**Source:** TSG CT WG4  
**Title:** Corrections on Camel4  
**Agenda item:** 8.3  
**Document for:** APPROVAL

⌘ **23.078 CR 772** ⌘ rev - ⌘ Current version: **6.5.0** ⌘

<b>Title:</b>	⌘ Correction to No_Answer handling in CAMEL_ICA_MSC2		
<b>Source:</b>	⌘ Ericsson		
<b>Work item code:</b>	⌘ Camel4	<b>Date:</b>	⌘ 27 April 2005
<b>Category:</b>	⌘ <b>A</b>	<b>Release:</b>	⌘ Rel-6
<i>Use one of the following categories:</i>		<i>Use one of the following releases:</i>	
<b>F</b> (correction)		<b>Ph2</b> (GSM Phase 2)	
<b>A</b> (corresponds to a correction in an earlier release)		<b>R96</b> (Release 1996)	
<b>B</b> (addition of feature),		<b>R97</b> (Release 1997)	
<b>C</b> (functional modification of feature)		<b>R98</b> (Release 1998)	
<b>D</b> (editorial modification)		<b>R99</b> (Release 1999)	
		<b>Rel-4</b> (Release 4)	
		<b>Rel-5</b> (Release 5)	
		<b>Rel-6</b> (Release 6)	
		<b>Rel-7</b> (Release 7)

**Figure 4.96-29: Process CS\_gsmSSF (sheet 29)**

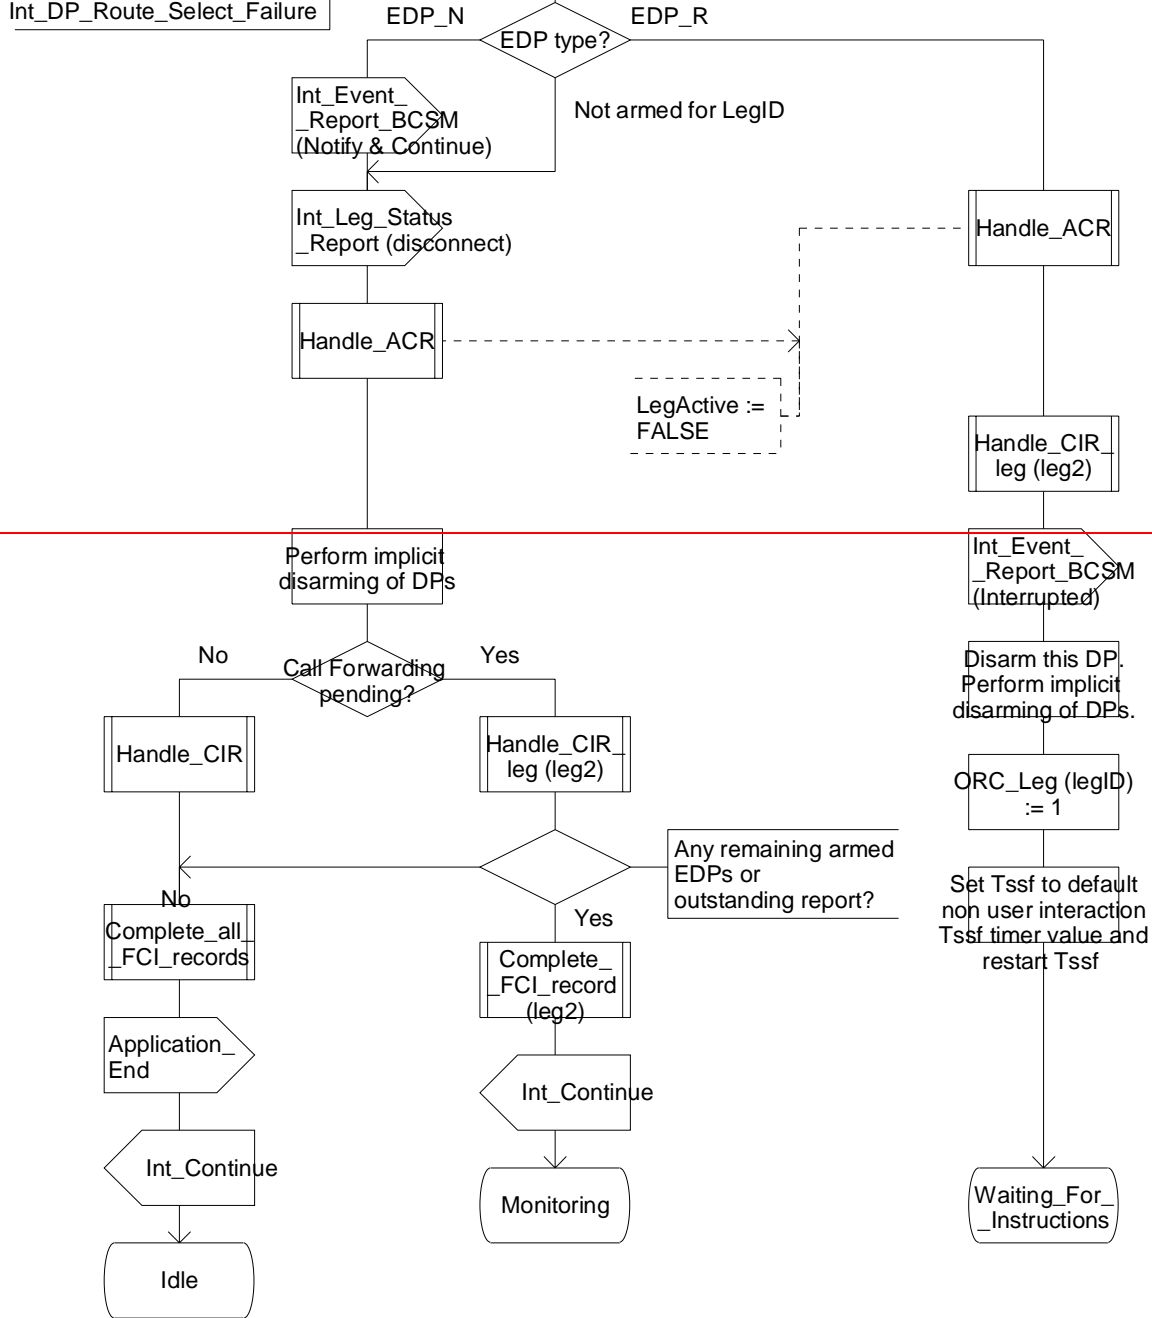
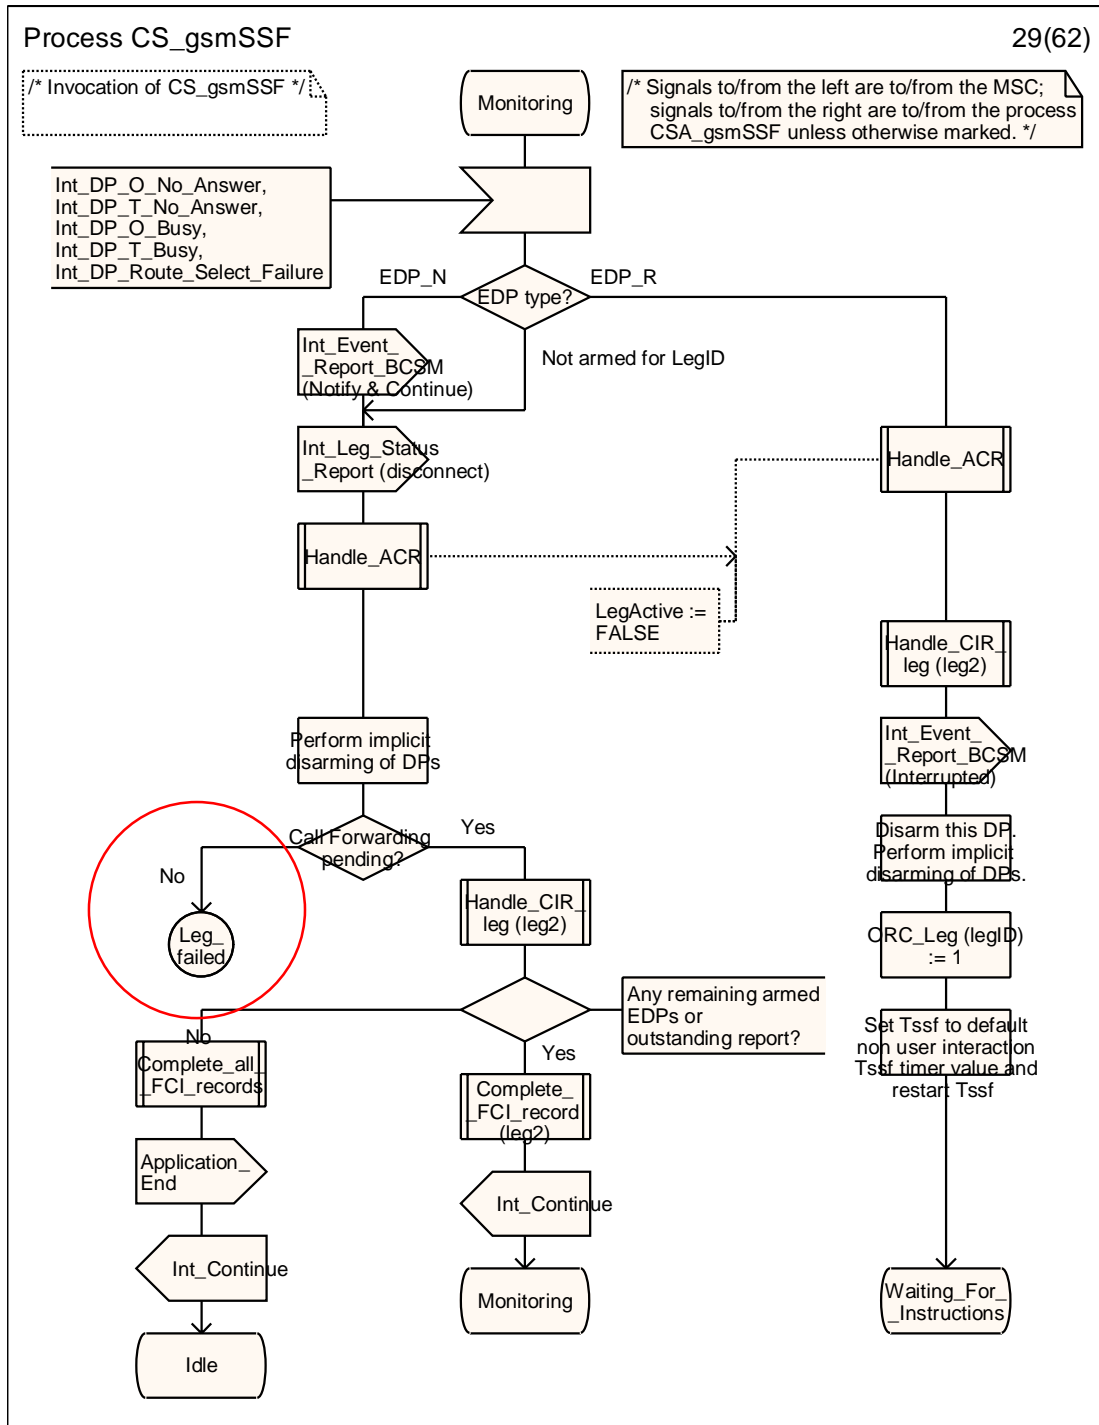
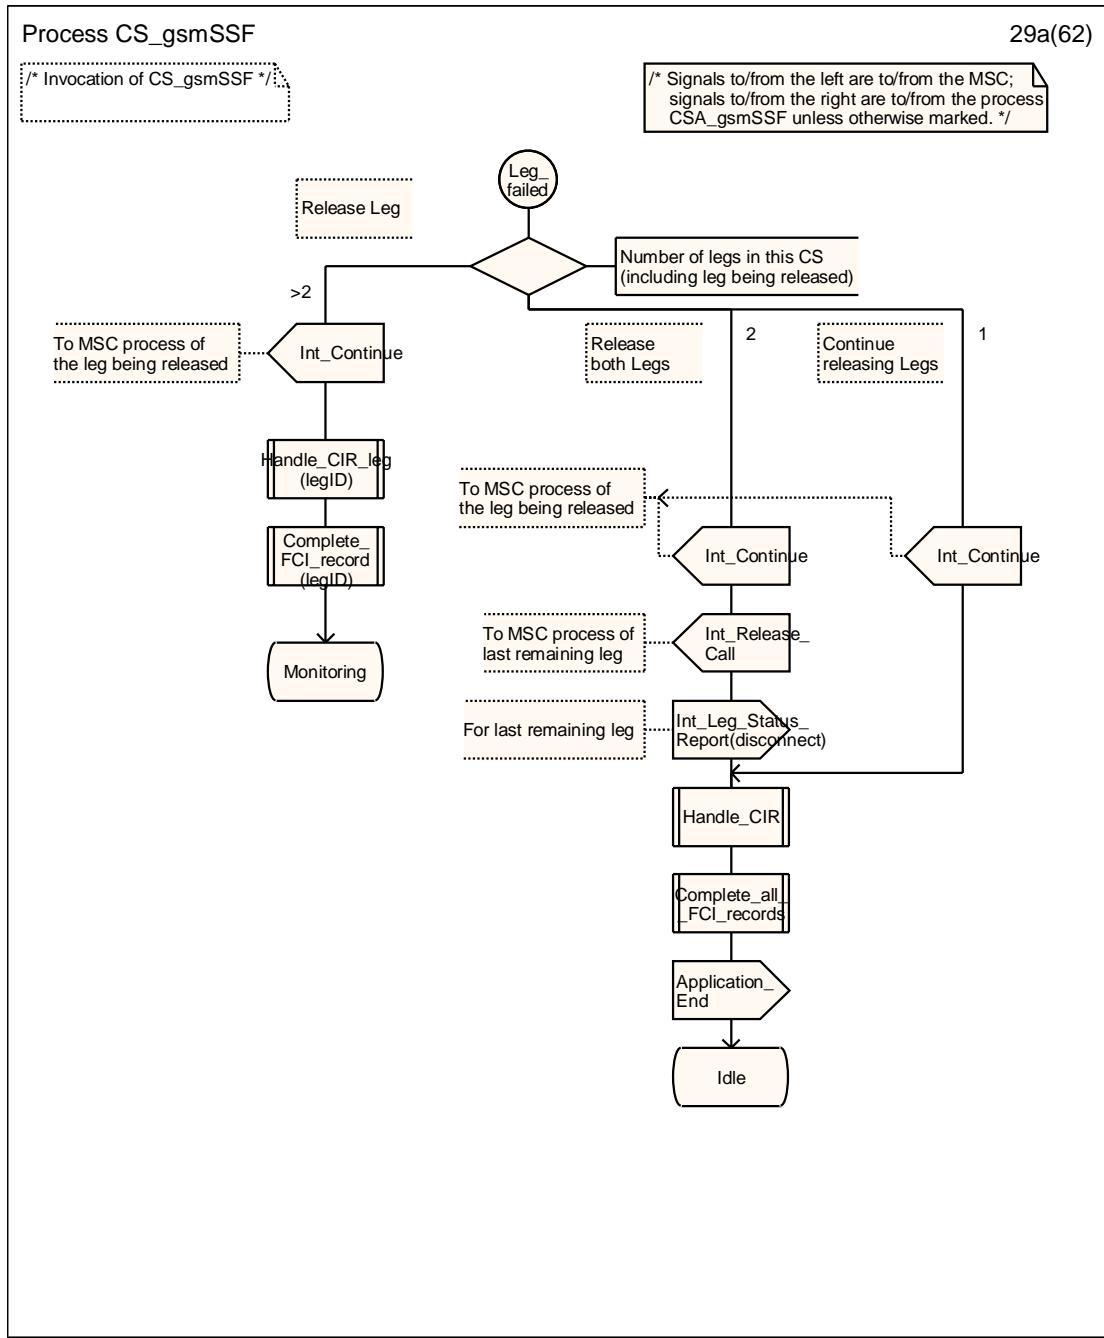
The handling of the call establishment failure events in process CS\_gsmSSF requires correction. It may happen that an ICA leg reaches the active state and is moved into Call Segment 1. Later on, a follow-on call is created for that ICA leg; the ICA leg is still in Call Segment 1. For this ICA follow-on call leg, the gsmSCF arms Busy, No\_Answer and Route\_Select\_Failure as EDP-N or does not arm these events at all. Meanwhile, there may still be other legs in Call Segment 1.

When the Busy event on the follow-on ICA leg occurs, the gsmSSF process will transit to Idle, even though there may be other legs in the Call Segment 1. For those other legs, the CAMEL control is now lost.

For CAMEL Phase 4, a check is required on the number of legs in the Call Segment; the number of legs in the call segment determines the action to be taken by the gsmSSF. This handling is already defined for the Disconnect case:

- if there are more than two legs in the Call Segment, then the failed leg is released and the other legs are retained;

- if there are two legs in the Call Segment, then the call will be released;
  - if there is one leg in the Call Segment, then the call will be released.
- This behaviour is required also for the call establishment failure case.

**Summary of change:** ⌘ Correct Process CS\_gsmSSF as described above.
